MSG-3 clean-up & standardizations

Dubai, UAE
May 2025

Introduction / Scope

Figure 2-3-9.1. Systems/Powerplant MSG-3 Logic Diagram – Level 3 Analysis

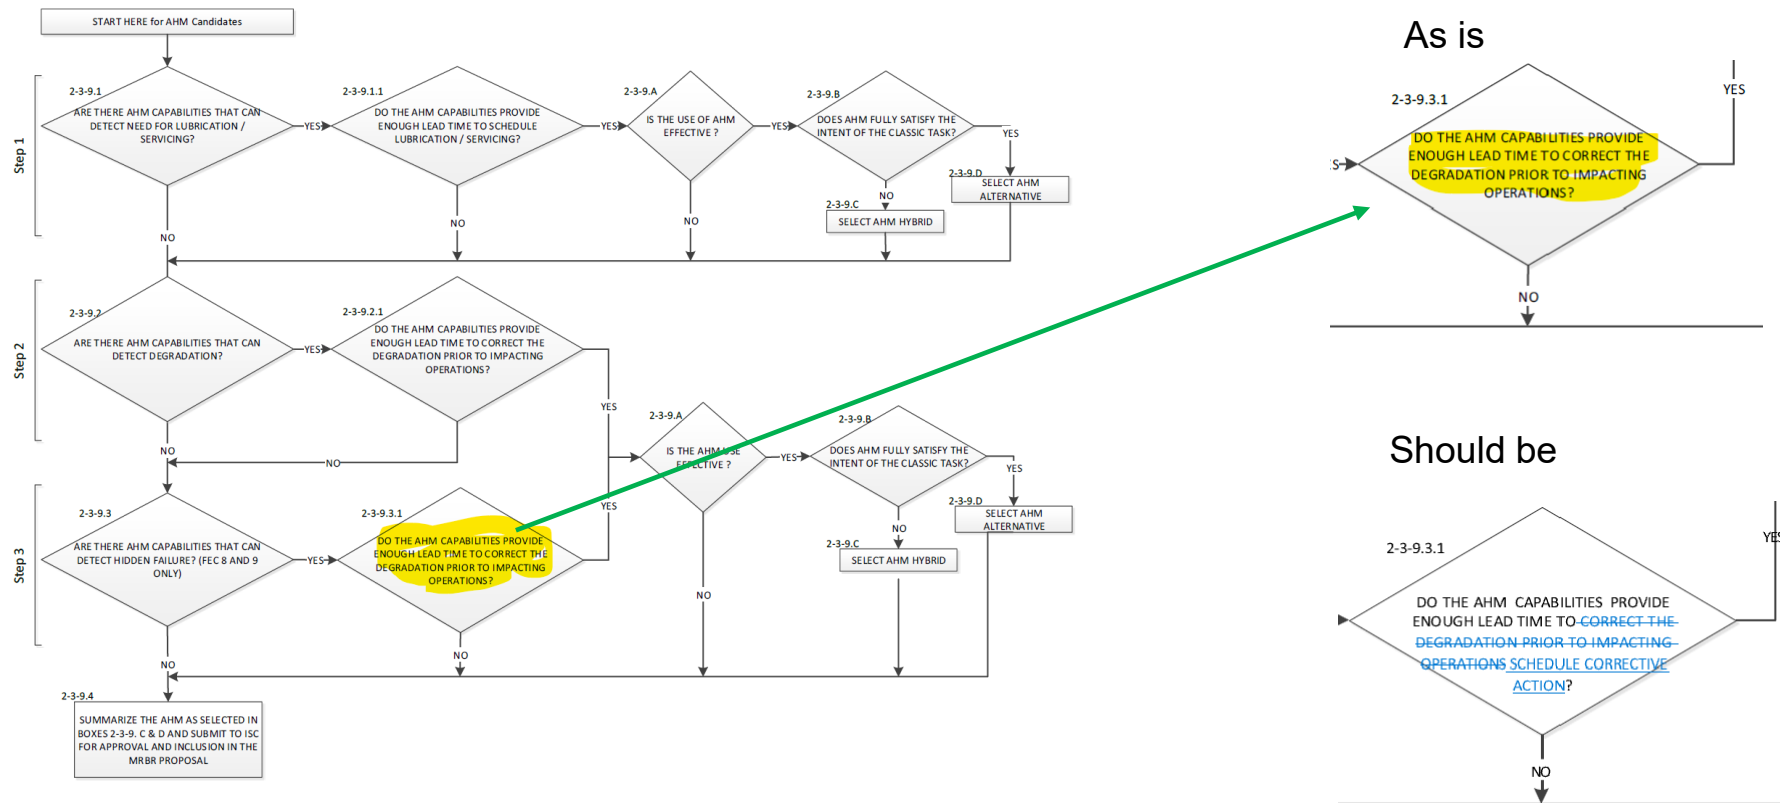
Diamond Box 2-3-9.3.1

- Text reads: “DO THE AHM CAPABILITIES PROVIDED ENOUGH LEAD TIME TO CORRECT THE DEGRADATION PRIOR TO IMPACTING OPERATIONS?”
- Text should read: “DO THE AHM CAPABILITIES PROVIDE ENOUGH LEAD TIME TO SCHEDULE CORRECTIVE ACTION?”
- This matches page 46, Step 3, Box 2-3-9.3.1: given this is a Hidden Functional Failure. See slide diagrams with “As is” “should be” extracts

This matches page 46, Step 3, Box 2-3-9.3.1

Box 2-3-9.3.1: DO THE AHM CAPABILITIES PROVIDE ENOUGH LEAD TIME TO SCHEDULE CORRECTIVE ACTION?

Figure 2-4-4.1: Structure MSG-3 Logic Diagram

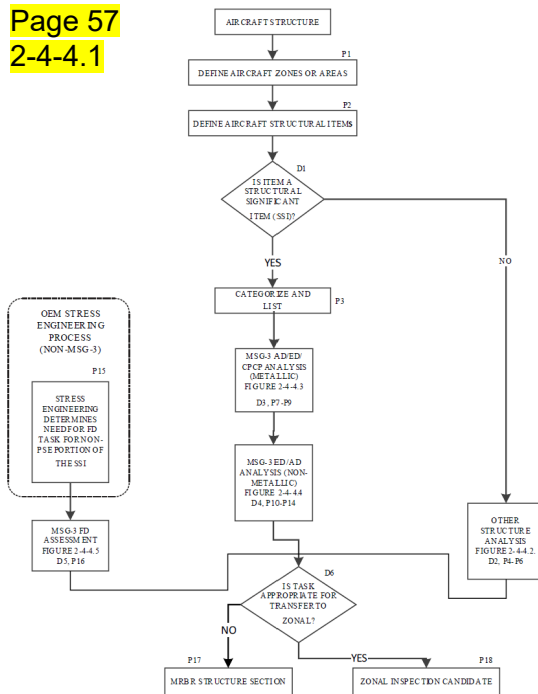
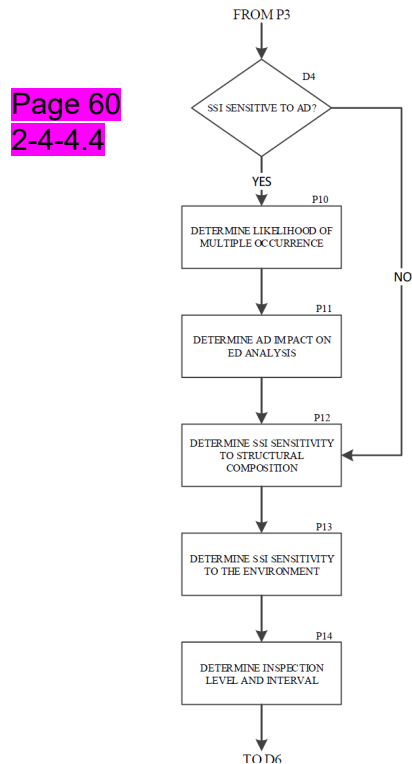
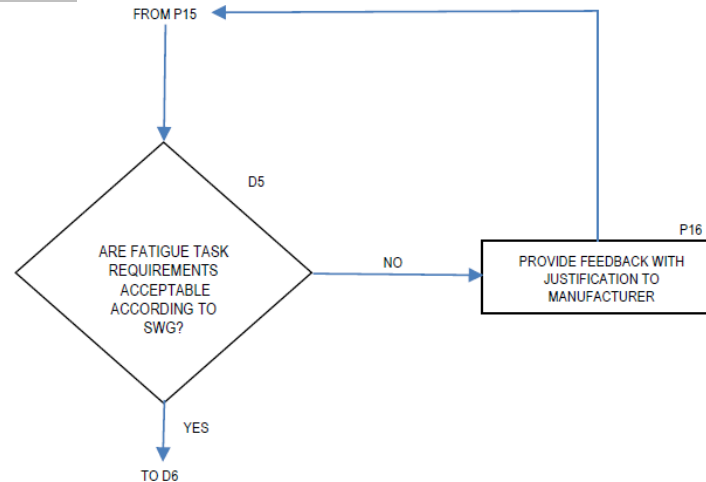
This logic is spread over 5 separate figures/pages (P.57: 2-4-4.1, P.58: 2-4-4.2, P.59: 2-4-4.3, P.60: 2-4-4.4, P.61: 2-4-4.5)

This logic is spread over 5 separate figures/pages (P.57: 2-4-4.1, P.58: 2-4-4.2, P.59: 2-4-4.3, P.60: 2-4-4.4, P.61: 2-4-4.5)

- Revise the primary logic flow figures for Structures Logic from multiple sub-figures to a single comprehensive figure
 - Condensed from 5 separate figures into one integrated figure
 - Corrected dual use of process step P5
 - renumbered second use of process steps number P5 to P10
 - renumbered existing process step numbers P-10 thru P18 to P11 thru P19 respectively
 - corrected mis-numbering (swap) of process steps P17 (now P18) and P18 (now P19) at the end of paragraph “e.” on page 55

Figure 2-4-4.3: Accidental Damage and Environmental Deterioration (Metallic) Logic Diagram

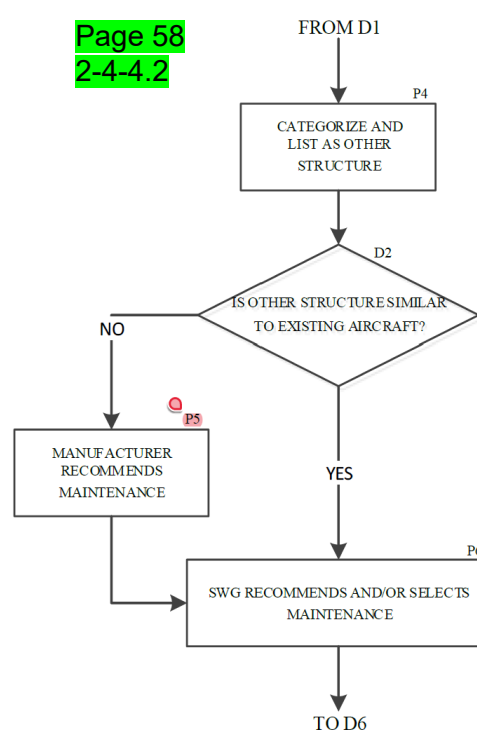
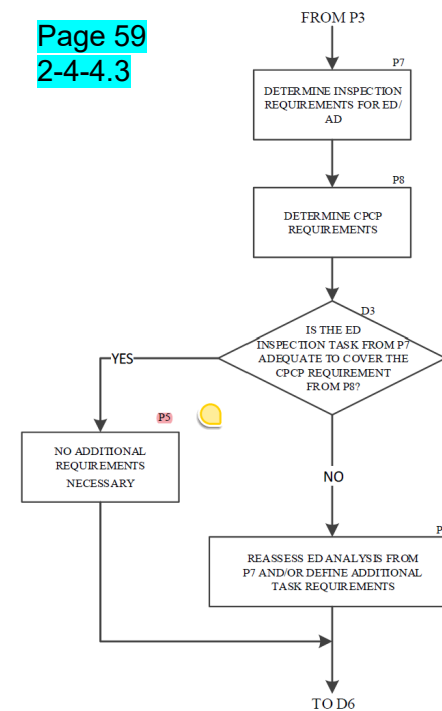
- Error was discovered while condensing/integrating the Structures logic
- Page 55, Section 2-4-4
 - 1. Procedure
 - Paragraph e.
 - Process step (P5) is used twice:
 - once in Figure 2-4-4.2. (Page 58) – where the text reads: “MANUFACTURER RECOMMENDS MAINTENANCE” and
 - once in Figure 2-4-4.3. (Page 59) – where the text reads: “NO ADDITIONAL REQUIREMENTS NECESSARY”

This creates a conflict. To resolve the conflict the second instance (Figure 2-4-4.3. (Page 59)) is renumbered as (P10), and the existing process steps P-10 thru P-18 (pages 55-56 and respective figure/s) are renumbered P-11 thru P-19, respectively.

(Note – Paragraph e. contains another error – the last sentence ended with “...either become a zonal inspection candidate (P17) or will be included in the scheduled structural maintenance (P18).” The numbers for these two process steps were inadvertently swapped. They need to be corrected as well as renumbered.

**Figure 2-2.1.
Integrated MSG-3
Systems/Powerplant
Analysis Logic
Diagram**

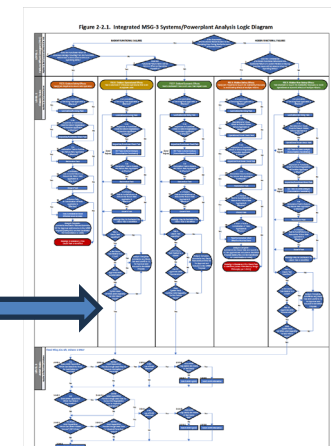
- Revise the primary logic flow figure for Systems/Powerplant Logic to change from multiple sub-figures to a single comprehensive figure
 - Condensed from a two-page figure into one integrated figure
 - (May need to be printed as a foldout – 17”x11”)
 - Added the new “Level 3” analysis
 - Added missing process steps to forward FEC 6, 7, and 9 GVI/VCK to Zonal for possible task consolidation
 - Added screening steps needed to pass from level 2 to level 3 analysis

Figure 2-5-1.1. Integrated MSG-3 Enhanced/Zonal Analysis Logic Diagram

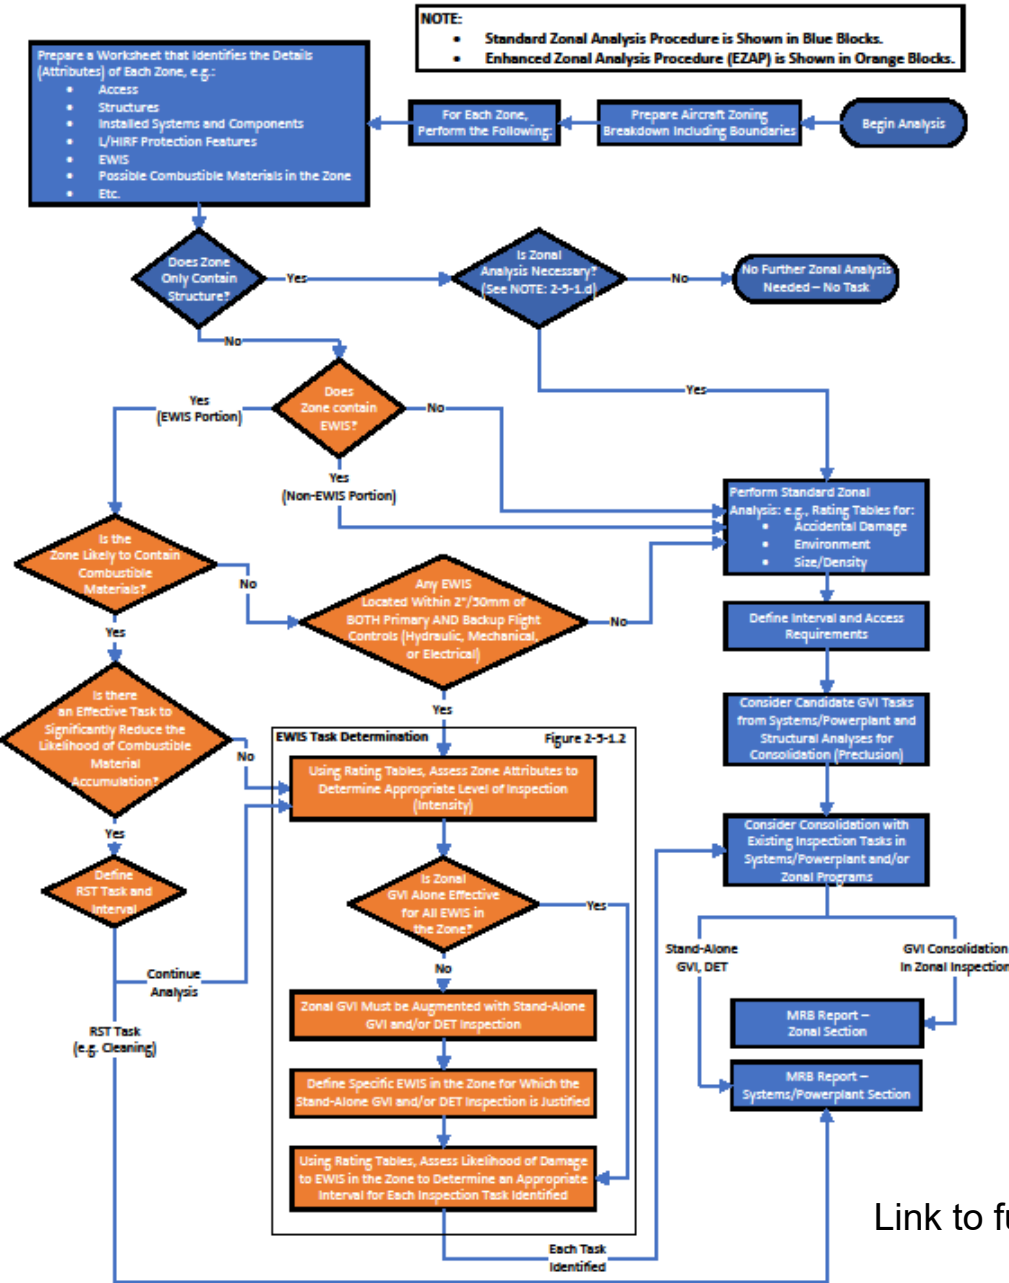
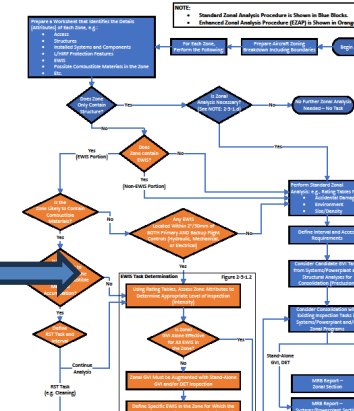
- Revise the primary logic flow figures for Zonal Logic to change from multiple sub-figures to a single comprehensive figure
 - Condensed from 2 separate figures into one integrated figure
 - Color-coded to differentiate the Enhanced Zonal analysis from the Standard Zonal analysis

Figure 2-6-1.1. Integrated MSG-3 L/HIRF Analysis Logic Diagram

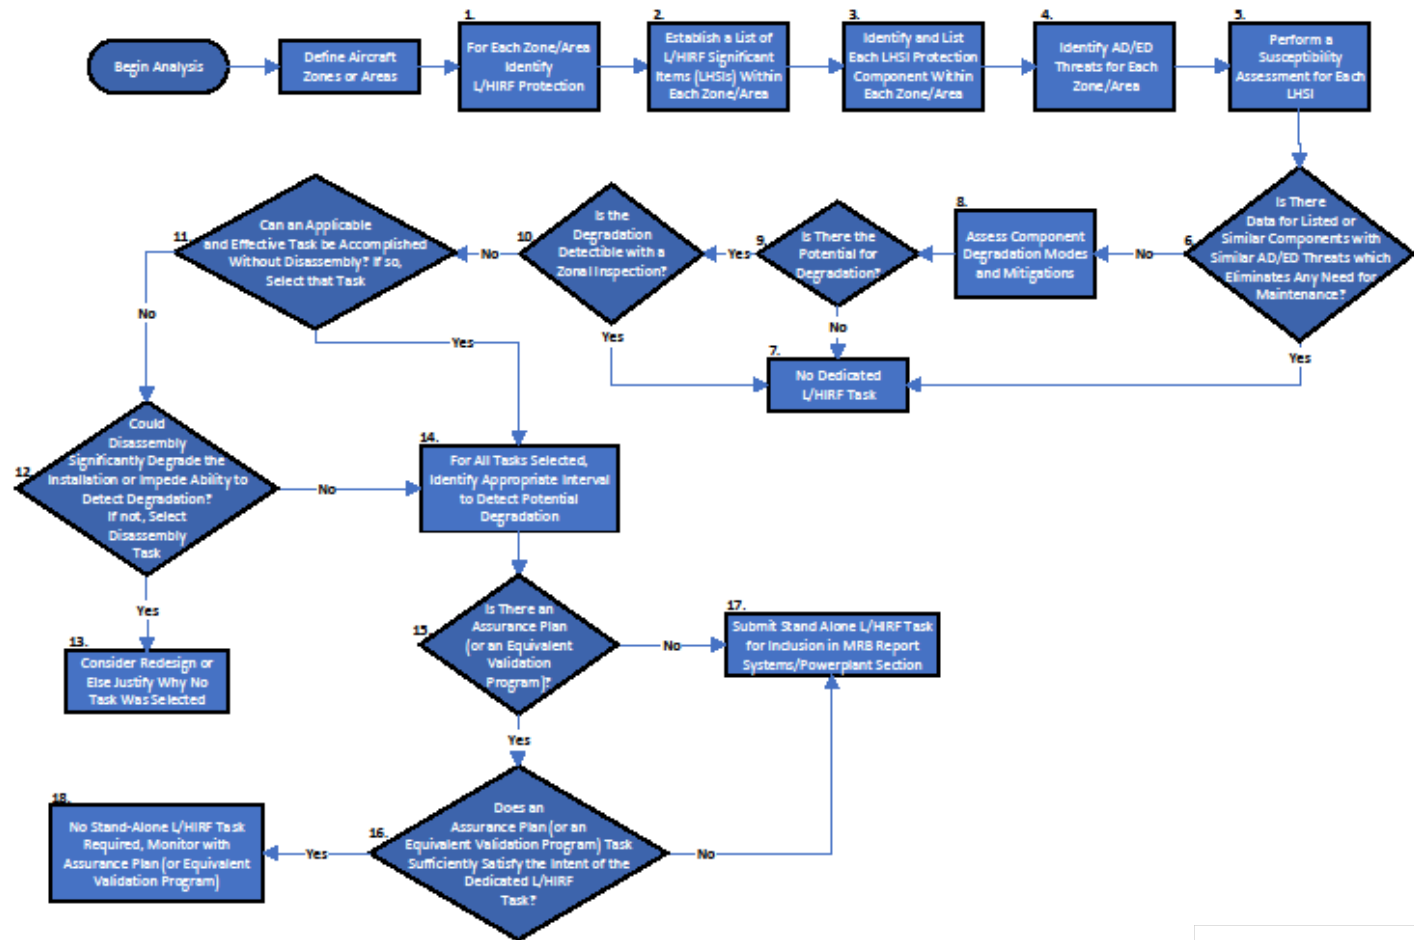
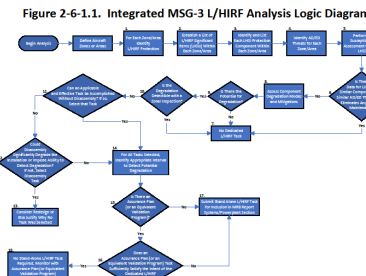
- Revise the primary logic flow figures for L/HIRF Logic to change from multiple sub-figures to a single comprehensive figure
 - Condensed from 2 separate figures into one integrated figure
 - Combined steps 7. And 10. Into a single block for clarity
 - Deleted step 10 from text of page 72 and renumbered Steps 11 through 19 to Steps 10 through 18 respectively
